# Village of Arlington Heights Building & Life Safety Department

**Subject:** PC 23-012 (Arlington Gateway Development - Phase I)

**PLAN COMMISSION PC #23-012**  
**Arlington Gateway**  
**1, 15 & 11 E Algonquin Rd, 2355 S Arlington Heights Rd**  
**Round 1**

Arlington Gateway Development  
PC 23-012  
October 4, 2023

# Turning Performance Analysis

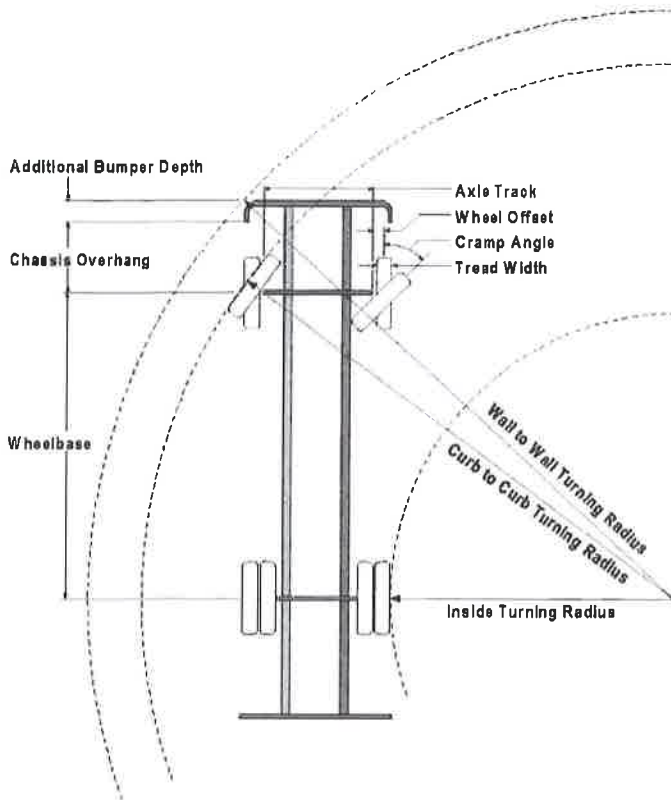
30. The fire truck exhibit does not reflect the Village's tower truck. Attached are the specifications for the tower apparatus.
31. Provide dimensions from the fire lane to the buildings.

SHEET TITLE  
LEVEL 4 FLOOR PLAN

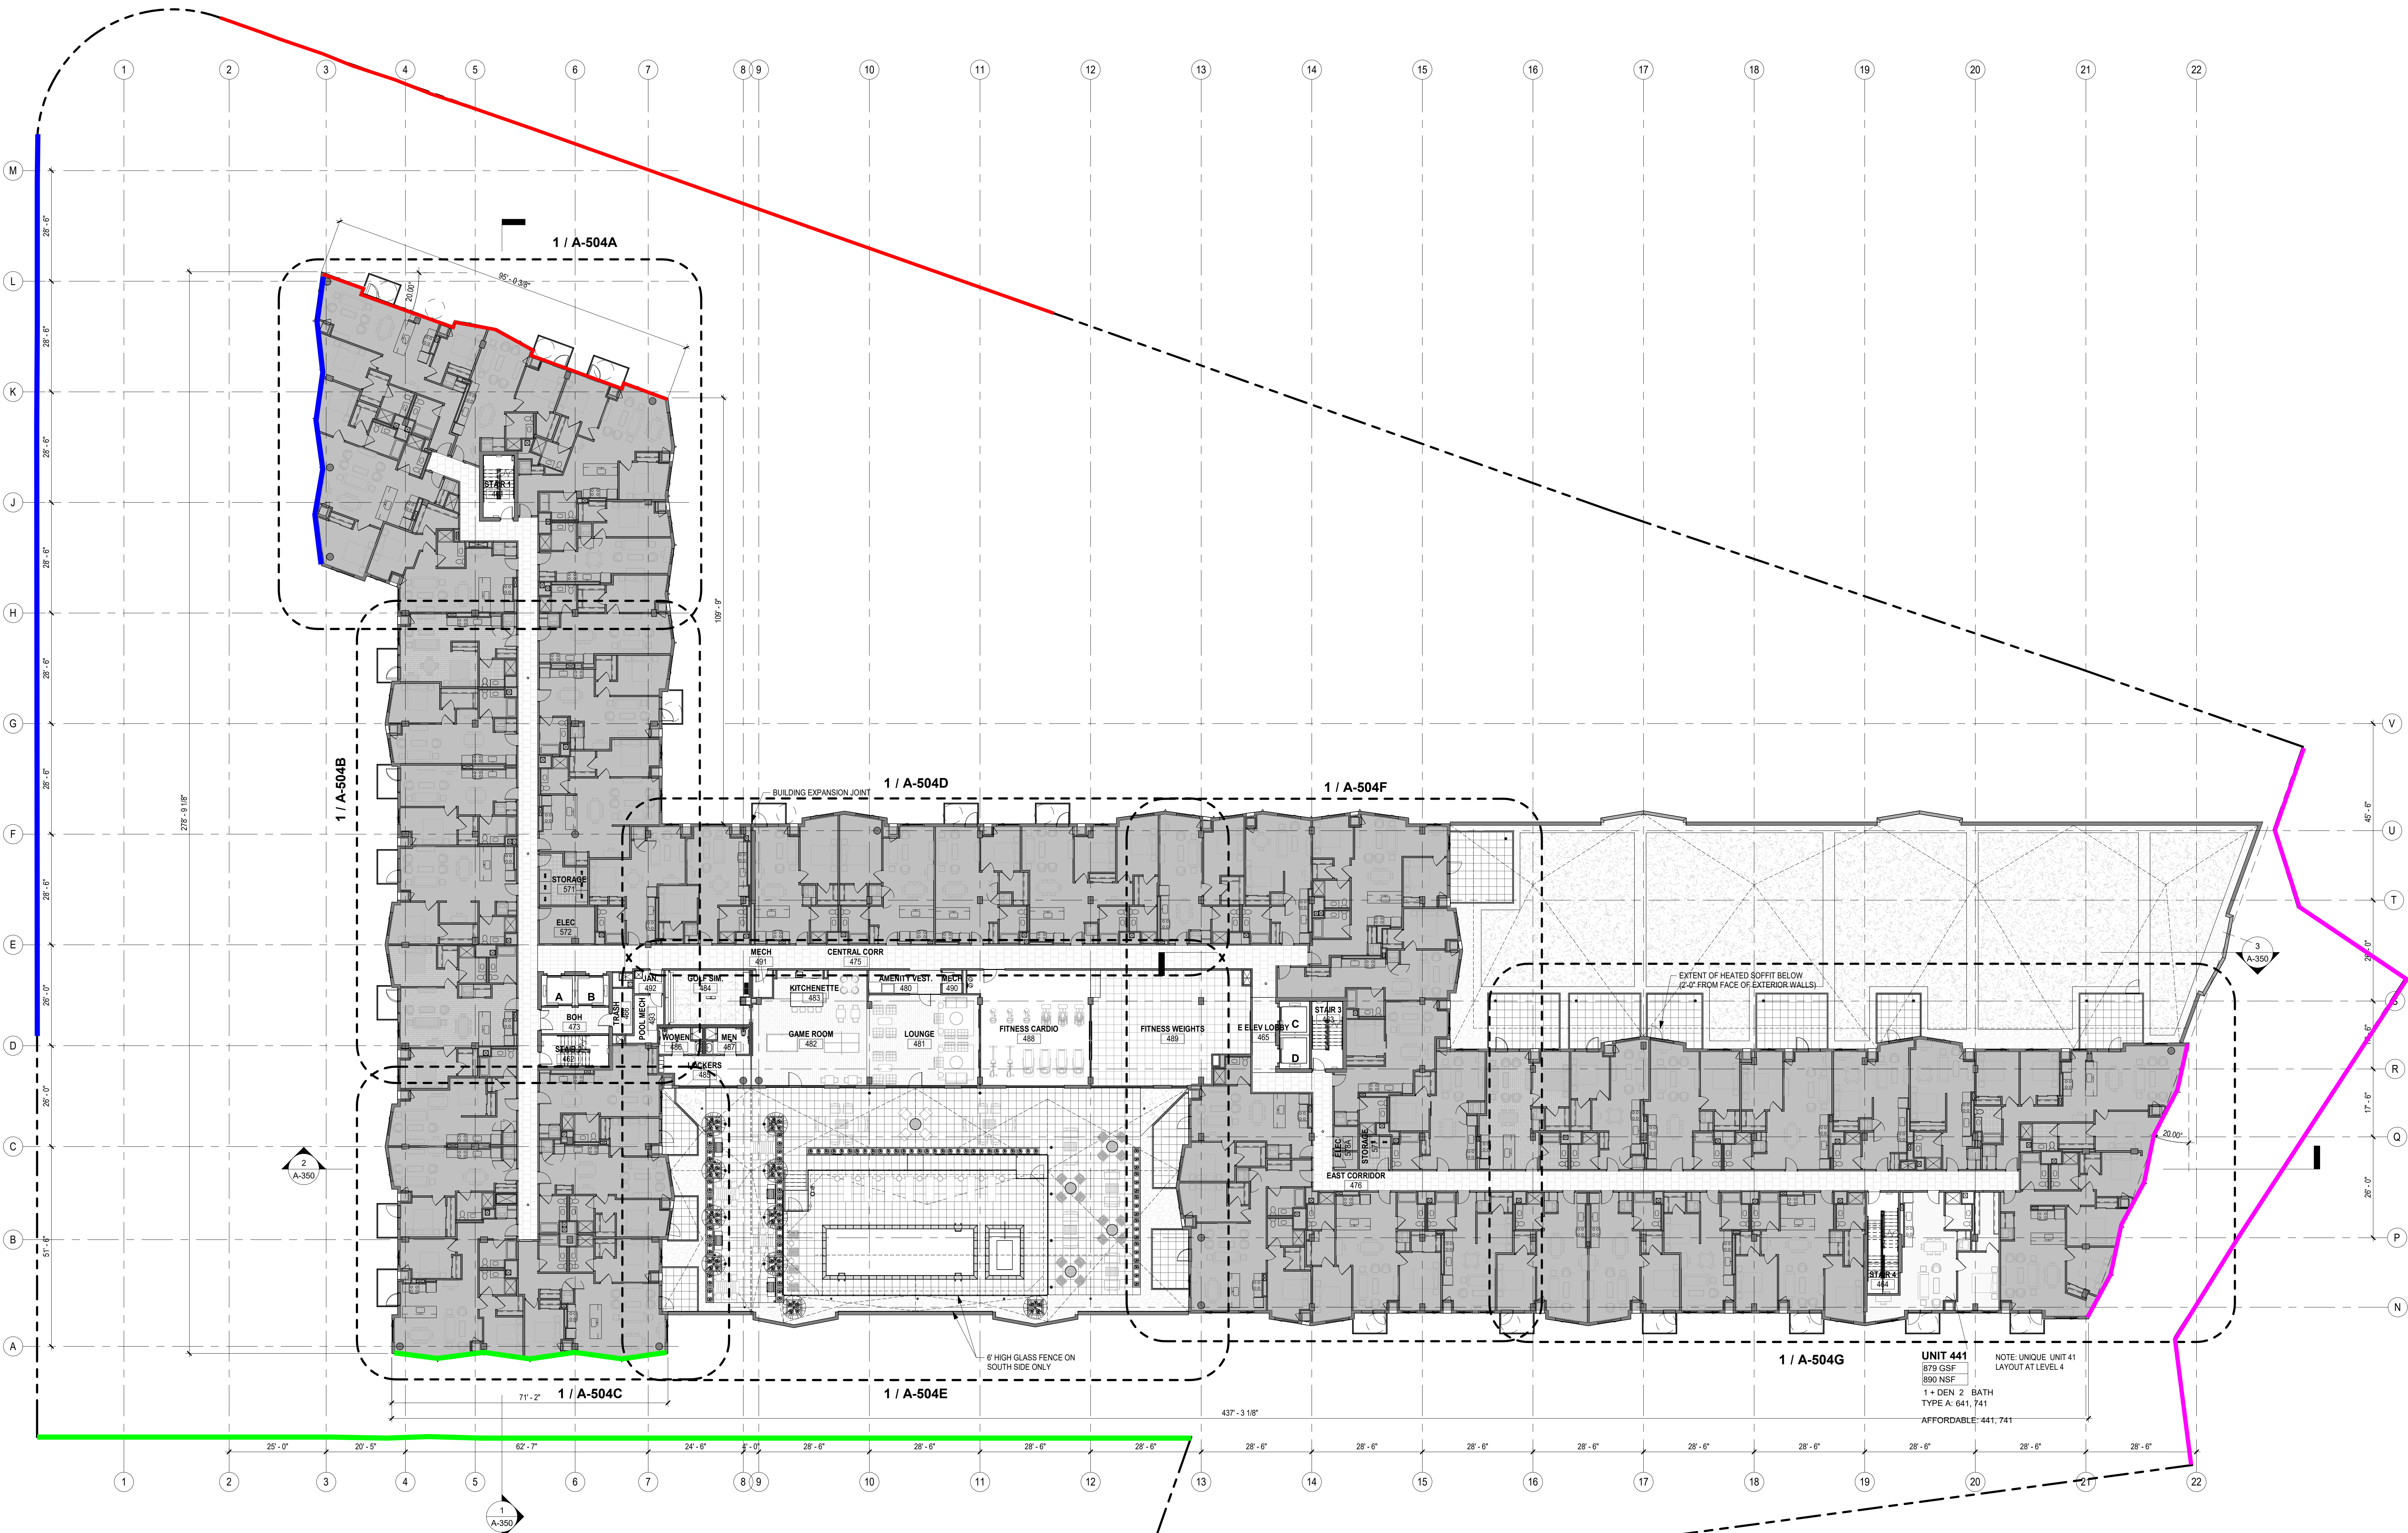
Please revise the architectural plans to clearly show the proposed building setbacks. Specifically, see the attachment at the end of these comments and revise the applicable sheets to clearly show the proposed setbacks of the building **at its closest point** from the colored elevations to the adjacent colored property line.

34. Balconies are only a permitted encroachment within a required rear yard. Per Code, the rear yard is the east side of the site abutting the privately owned Tonne Road parcel. Balconies that project outwards past the front plane of the structure on the north, south, and west elevations in areas where the front plane of the structure already encroaches into a required setback, will require a variation to further project into the required setback. Please provide details to verify the extent of variations as may be required.

**Landscape Issues**

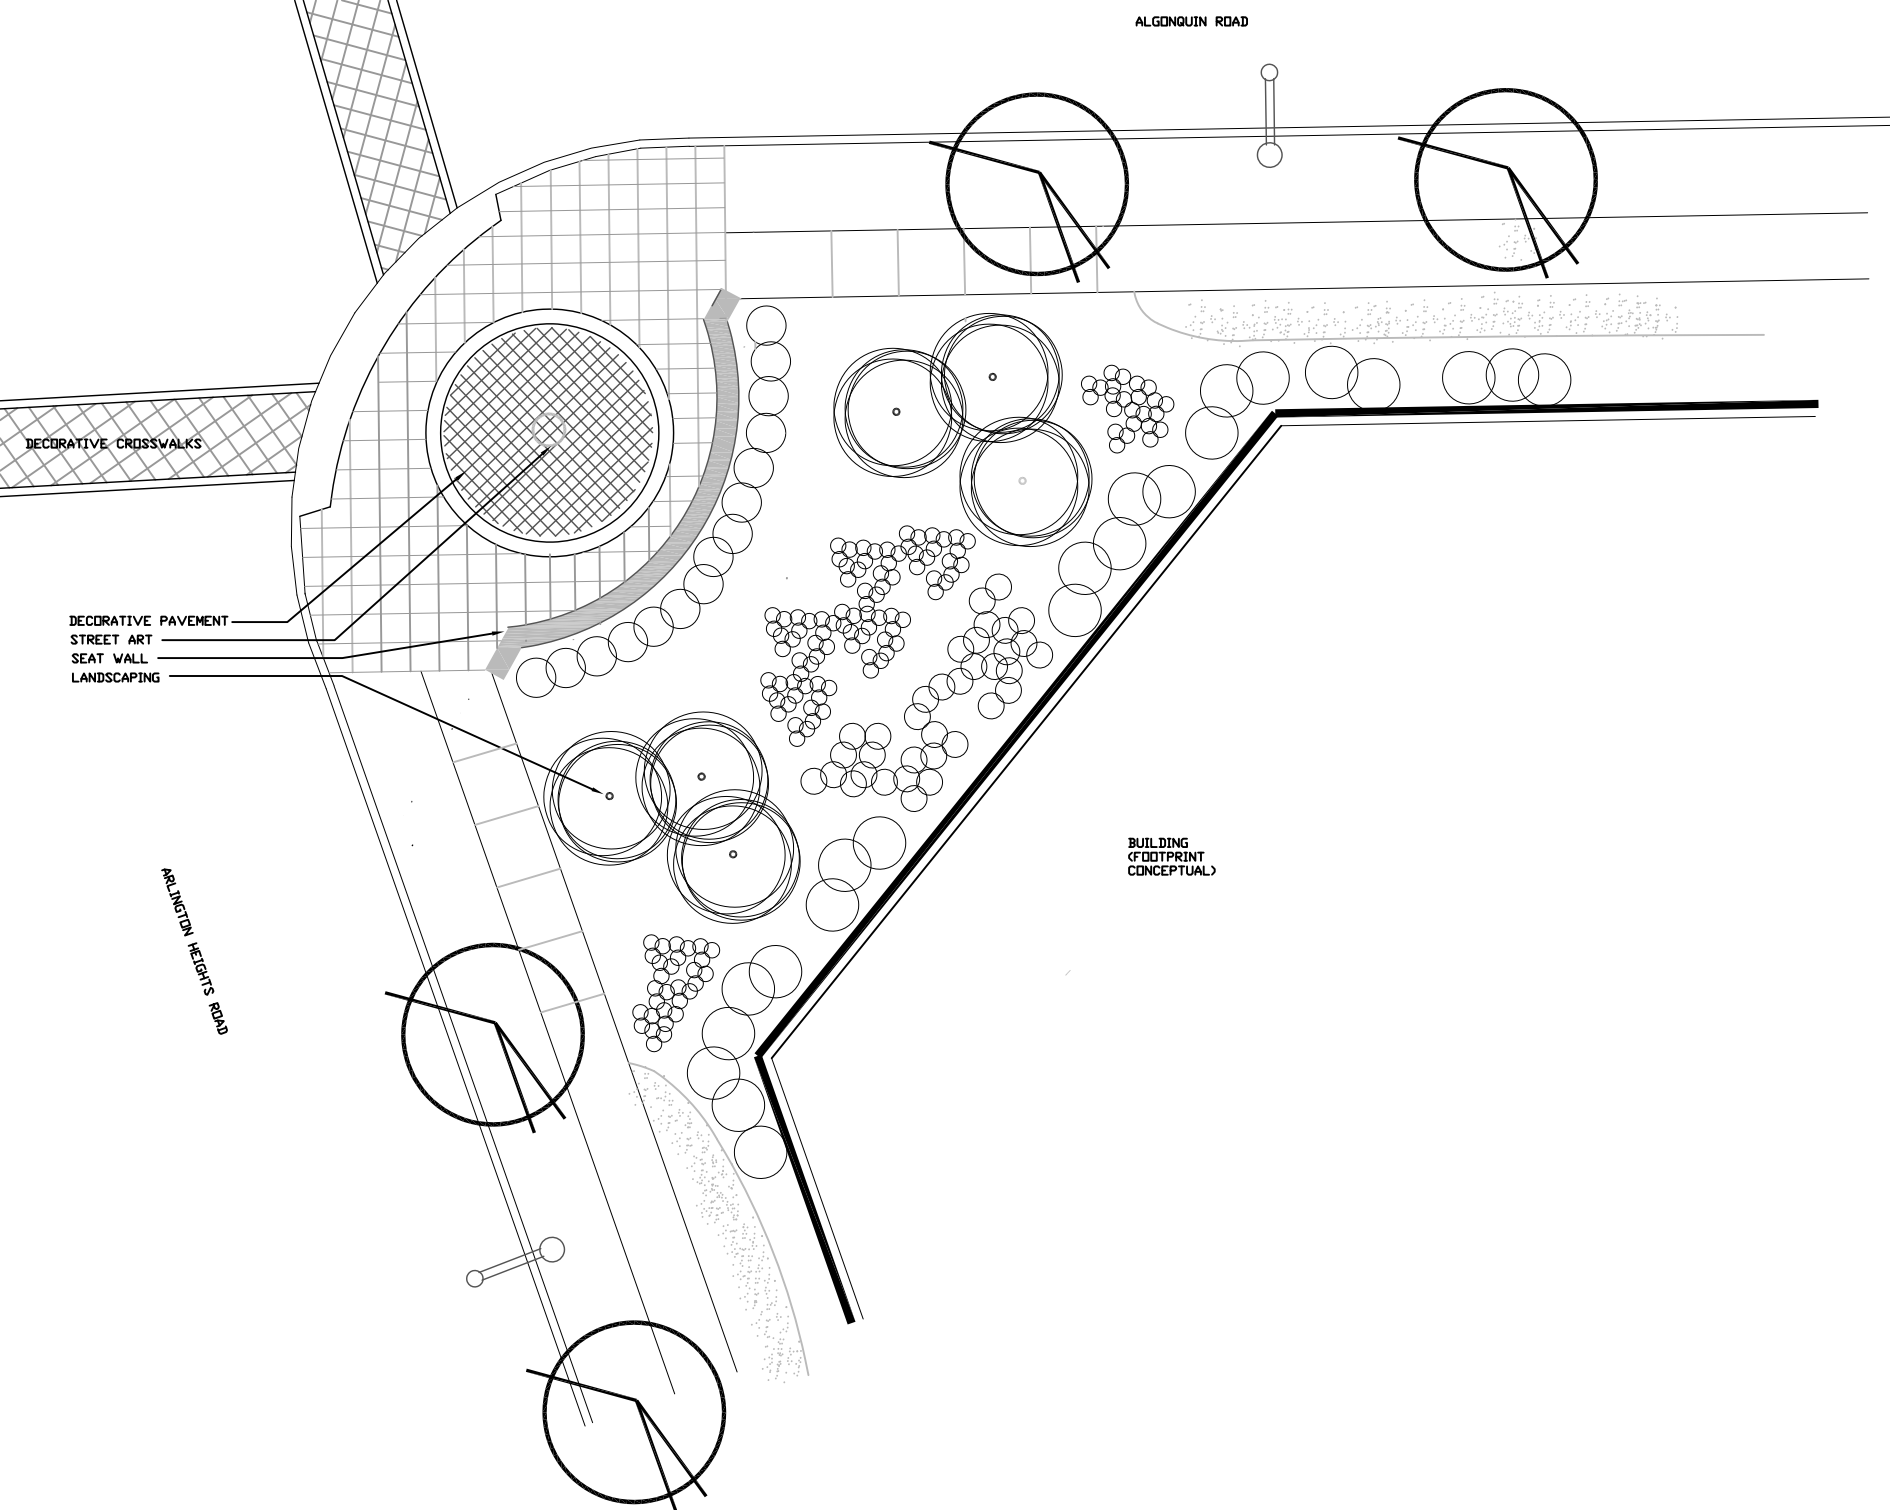
- 1) The overall landscaping is minimal. Please incorporate foundation plantings for the area located near the northwest corner of Arlington Heights Road and Algonquin Road. In addition, please incorporate foundation plantings for the area near Tonne Road and Algonquin Road. There should be an abundance of landscaping at both Tonne/Algonquin Road and Arlington Heights Road/Algonquin Road. The planting should be a mix of shrubs and perennials and take into consideration the design of the building elevation.

- 2) Provide parkway trees along Arlington Heights Road, Algonquin Road and Tonne Road. Please incorporate a variety of shade trees that are spaced approximately 40-50 feet apart. The trees should be 2.5 inch caliper at time of installation. The species must be salt and drought tolerant.

- 4) Specialty pavement is shown on the landscape plan and the engineering plan (Sheet L-100 & C3.0). Please note that the plans are inconsistent. The landscape plan shows specialty pavement that consists of stripes between the buildings. Please clarify the materials and coordinate so that the plans are consistent. In addition, please provide details for the pavers and the striped areas.

- 5) At the corner of Arlington Heights Road and Algonquin Road incorporate an expanded pedestrian area that includes specialty pavement, seat walls and landscaping. The area should contribute to the focal point and provide pedestrians a generous area of relief at the corner. Please see the attached concept.
